**TOWN OF MOUNTAIN VILLAGE
REGULAR DESIGN REVIEW BOARD MEETING AGENDA
THURSDAY JUNE 6, 2024, 10:00 AM
MOUNTAIN VILLAGE TOWN HALL
455 MOUNTAIN VILLAGE BLVD, MOUNTAIN VILLAGE, COLORADO
TO BE HELD HYBRID THROUGH ZOOM:**

3.	10:02	15	Perez/ Applicant	Quasi-Judicial	Review and Recommendation to Town Council regarding a height variance for Lot 165 Unit 2, TBD Cortina Dr, pursuant to CDC Section 17.4.16.

4.	10:17	30	Perez/ Applicant	Quasi-Judicial	Consideration of a Design Review: Initial Architecture and Site Review for Lot 165 Unit 2, TBD Cortina Dr, pursuant to CDC Section 17.4.11.

5.	10:47	30	Nelson/ Applicant	Quasi-Judicial	Consideration of a Design Review: Final Architecture Review for Lot 926R, TBD Sundance Lane, pursuant to CDC Section 17.4.11. <i>This item was continued from the March 7, 2024, Design Review Board Meeting.</i>

1 Site Plan CMP

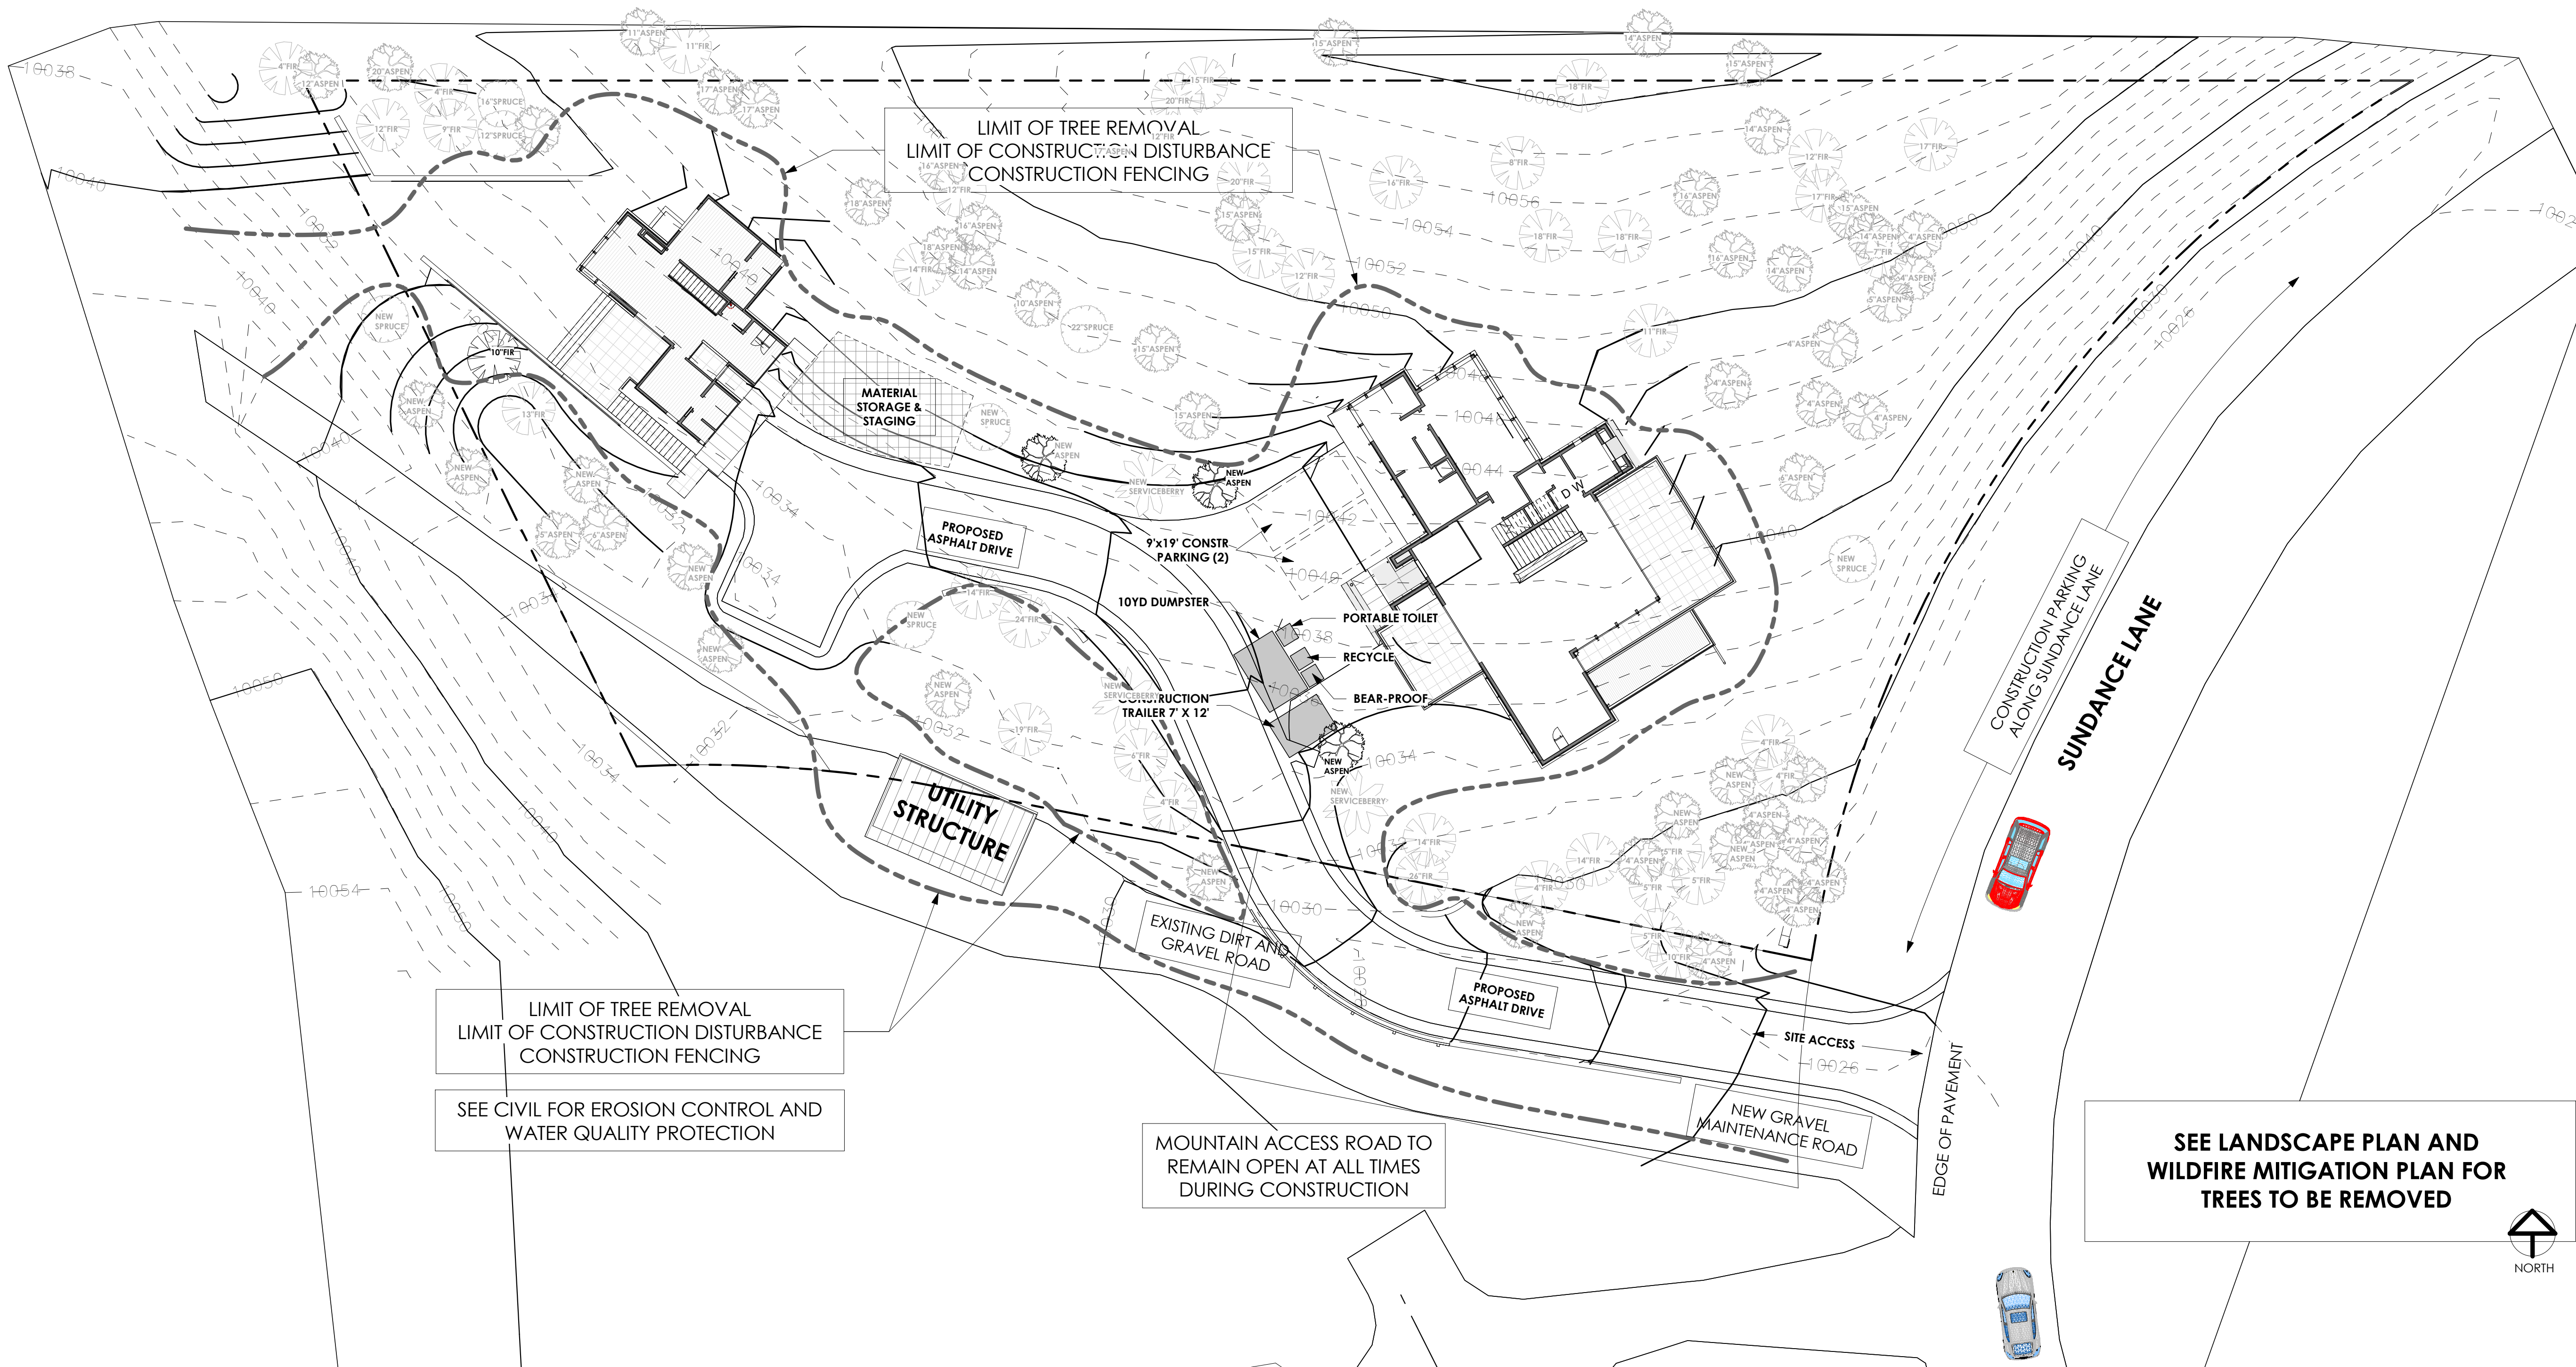
Staff: A construction mitigation plan is provided on Sheet A0.11. The plan indicates the location of construction parking, storage area, dumpster area, the location of portable toilet and construction trailer, limits of disturbance and fencing and tree protection. Erosion control and water quality protection plan is shown separately on Sheet C4. The applicant needs to coordinate with Public Works related to a temporary right-of-way encroachment permit for parking.

3 Main - Maximum Roof Height Points
SCALE 0 1 2 4 8 1/8" = 1'-0"
TRUE NORTH PROJECT NORTH

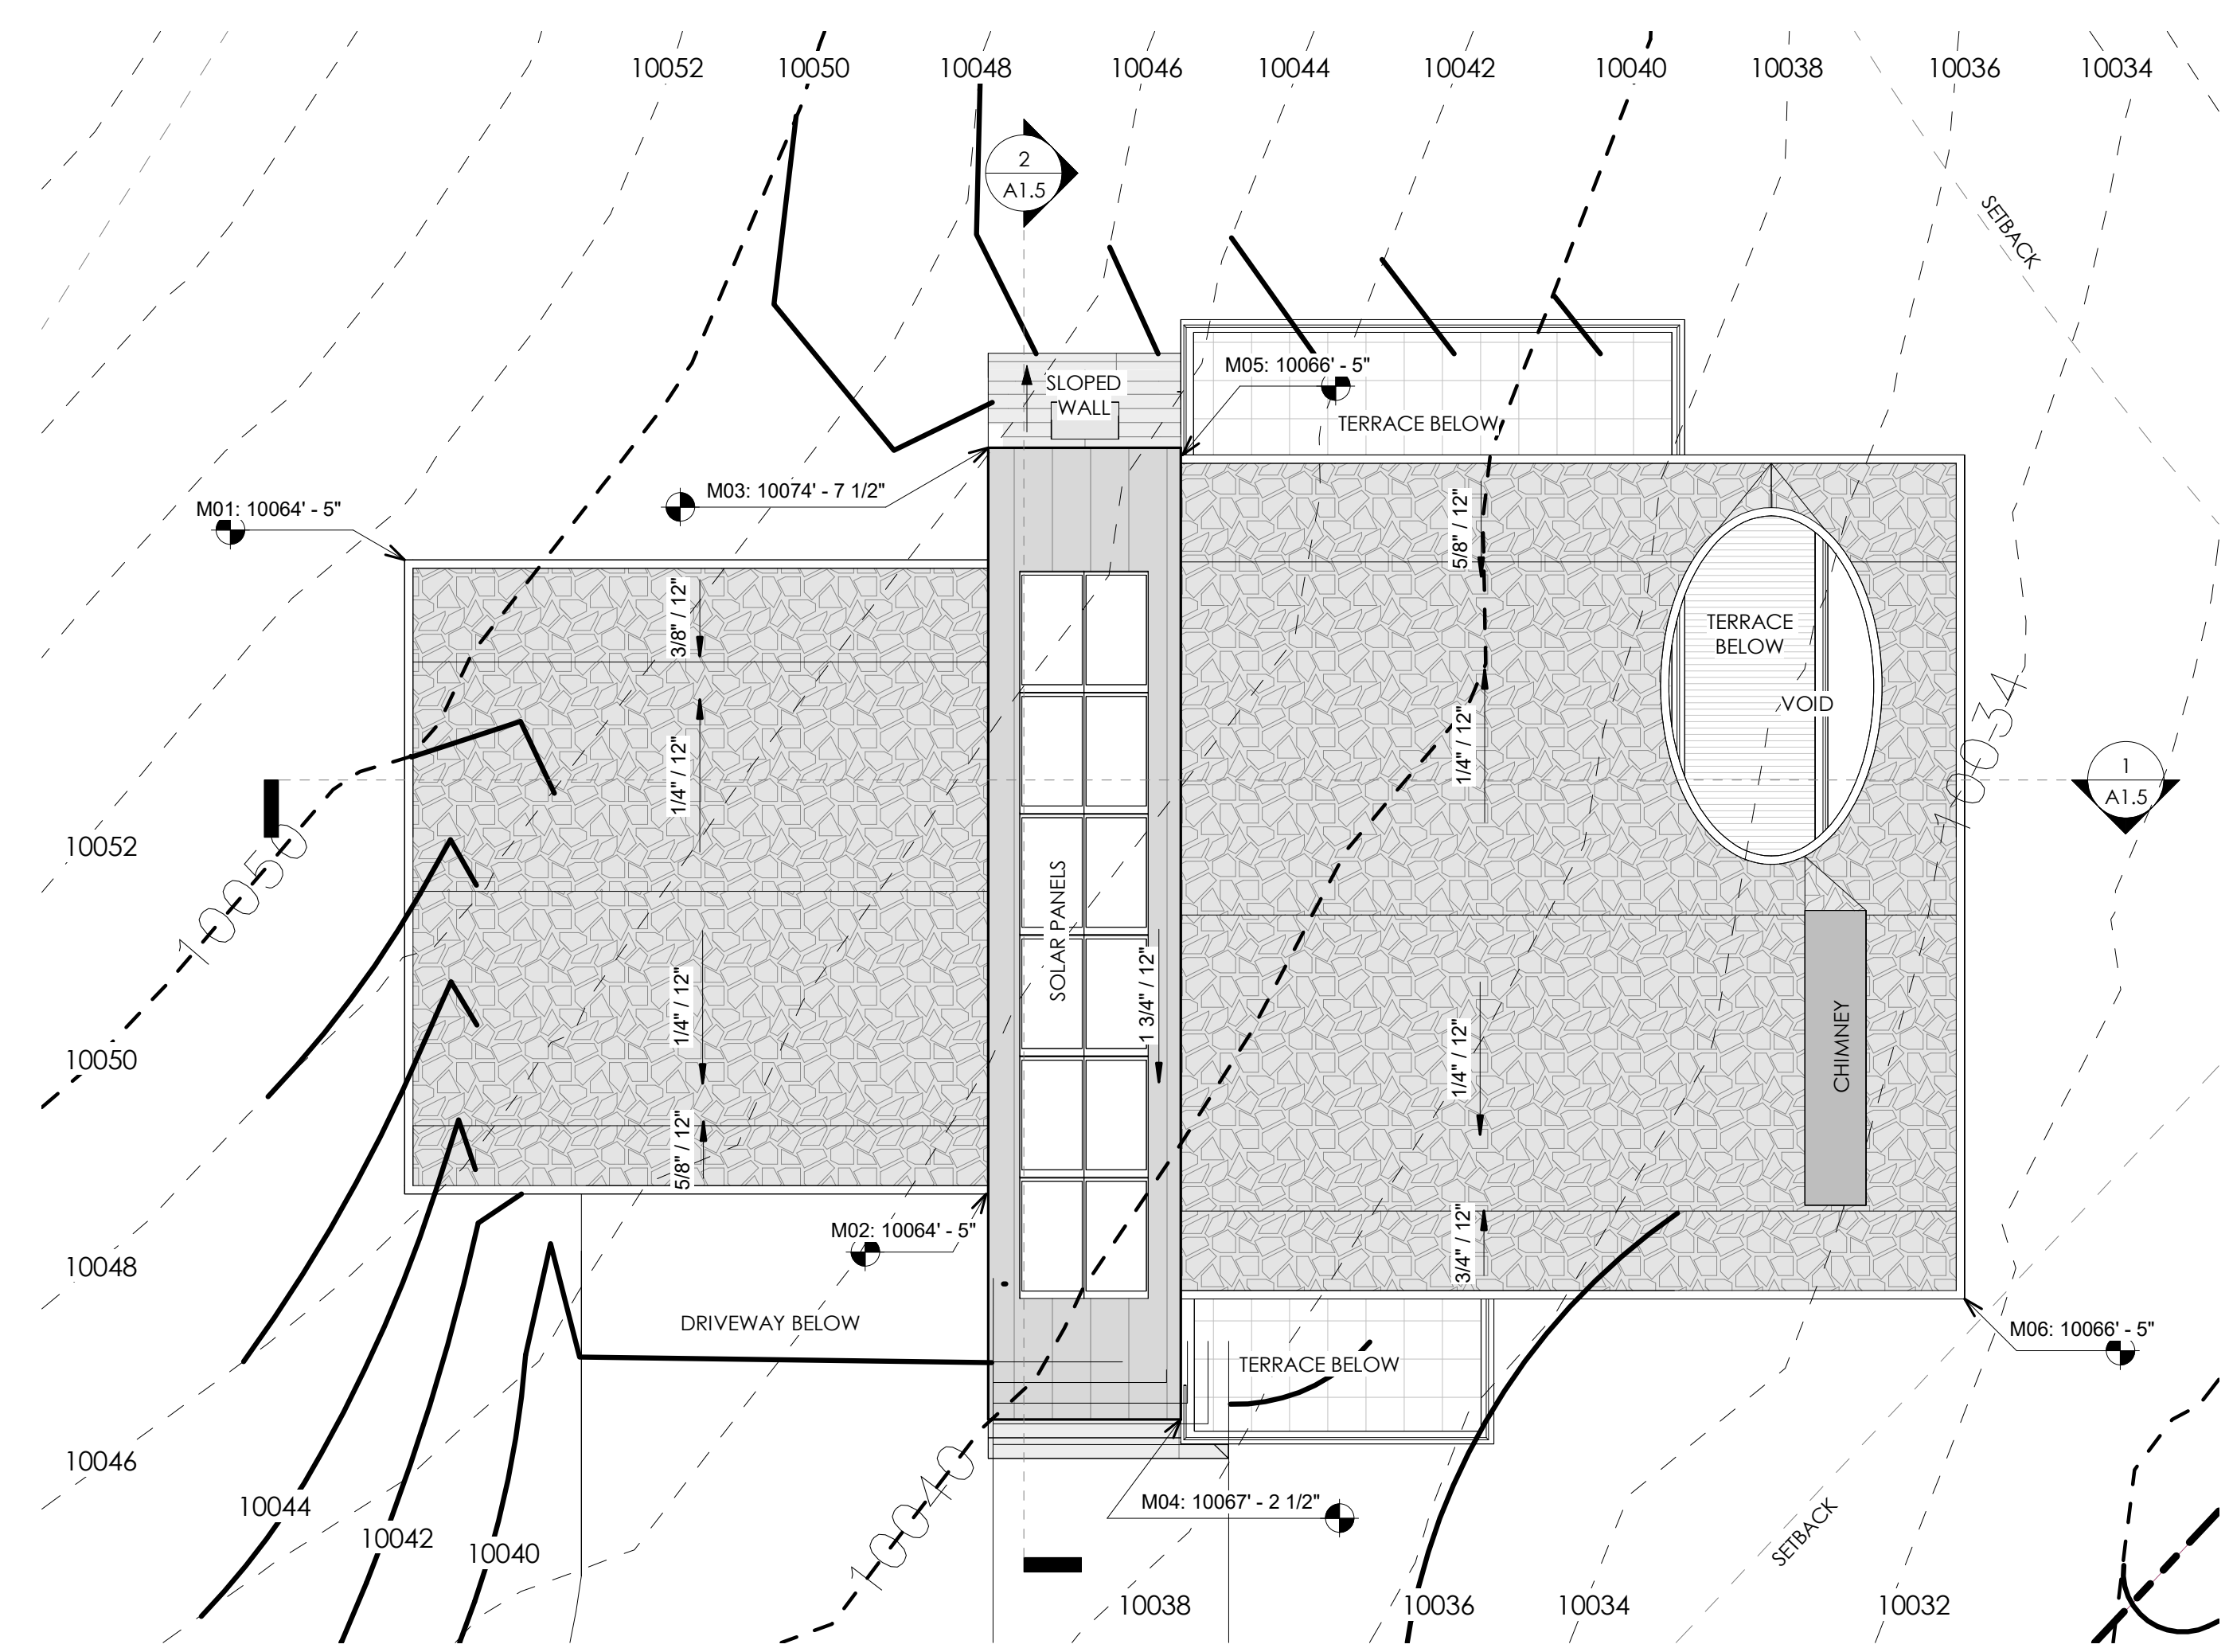
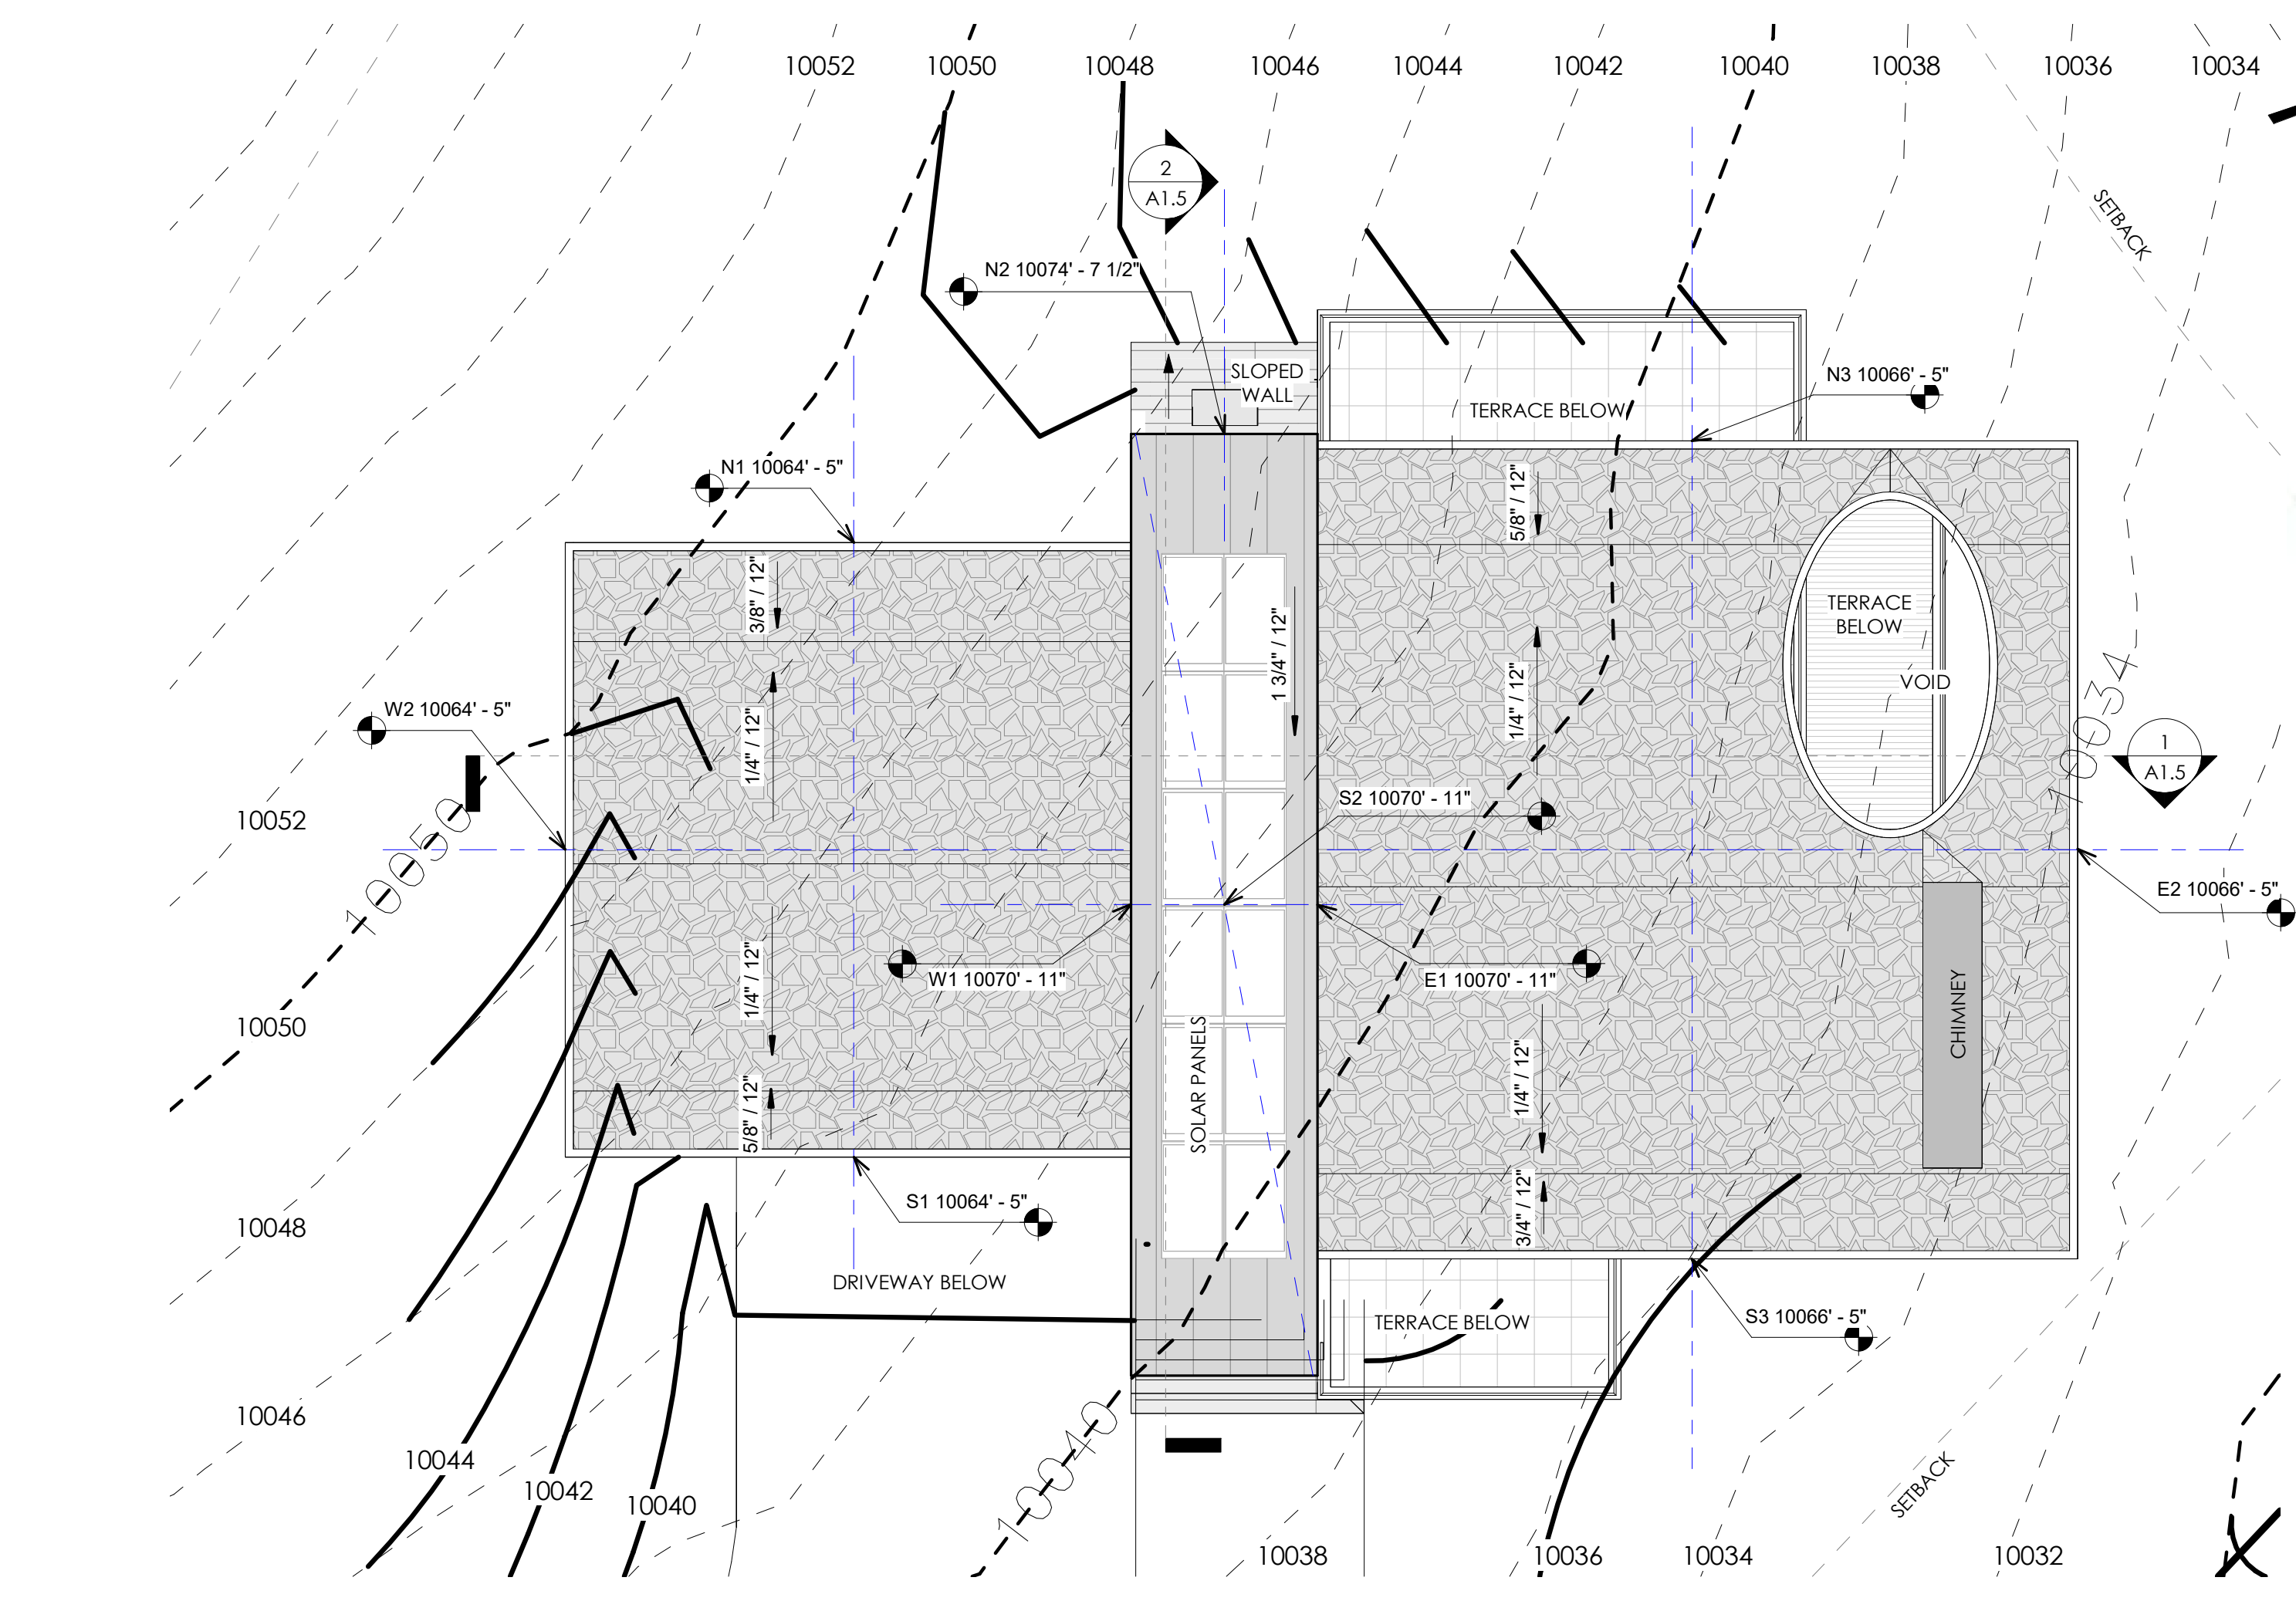
Staff: Staff have determined that the primary roof form for the proposed structures is flat and therefore granted a maximum height of 35’ and an average height of 30’. According to Sheet A1.5 and A1.6 of Exhibit A, the applicant has calculated a maximum height of 33.92’ and an average height of 26.59’ for the main structure and a maximum height of
